Technical Service Bulletin

60 Seal for Panoramic sun roof has changed

60 19 33 2055582/1 July 17, 2019.

Model(s)	Year	VIN Range	Vehicle-Specific Equipment
A7	2019	00001 – 032040	Panoramic sunroof

Figure 1. The part number has been updated to 4K8 877 781 A or higher.

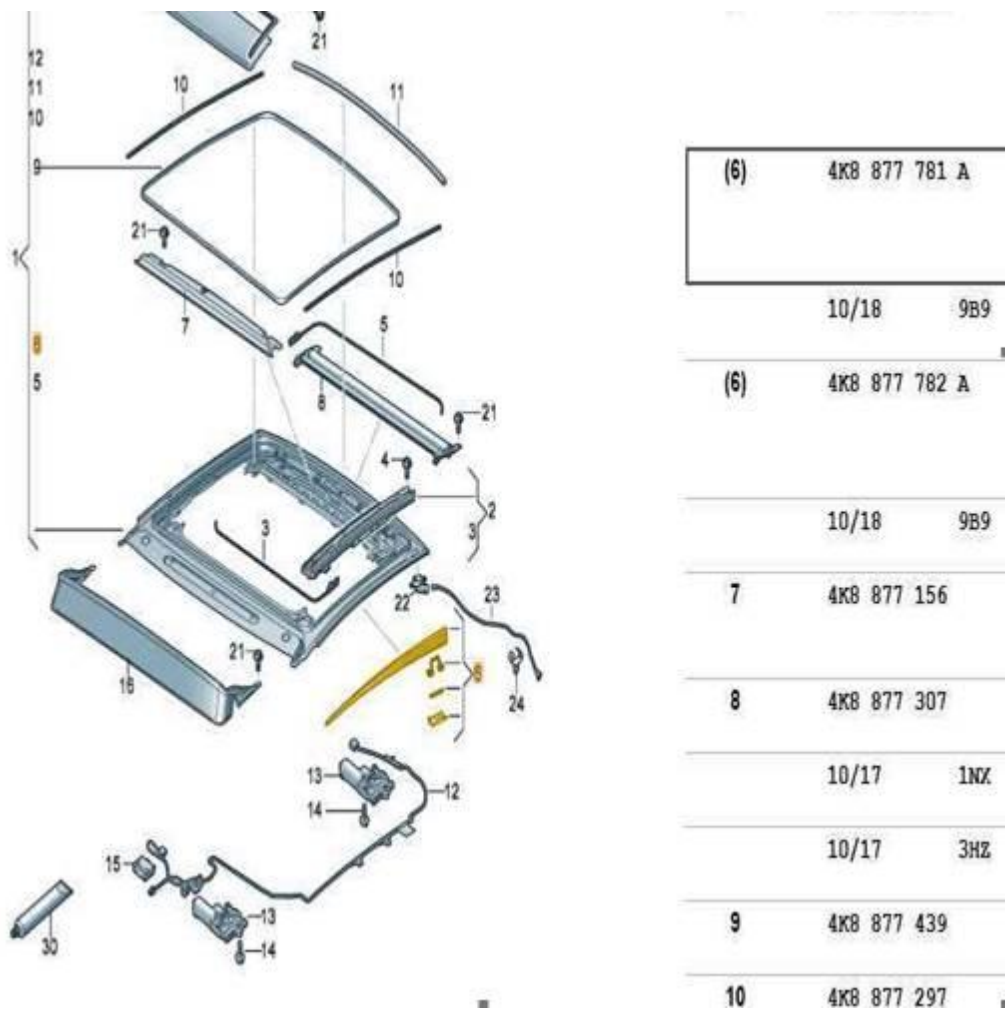
The pop-up panels on the Panoramic sunroof have changed (Figure 1).

Figure 2. Position change for the seal/bellows.

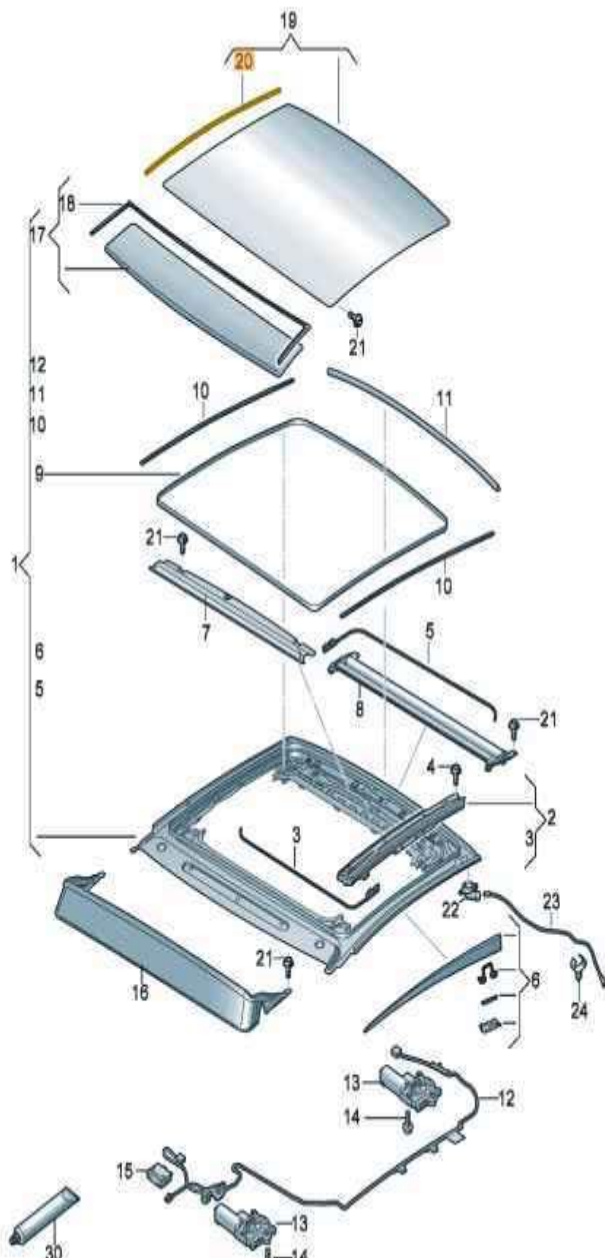
This requires a change in the installation position of the seal in position 20 (Figure 2).
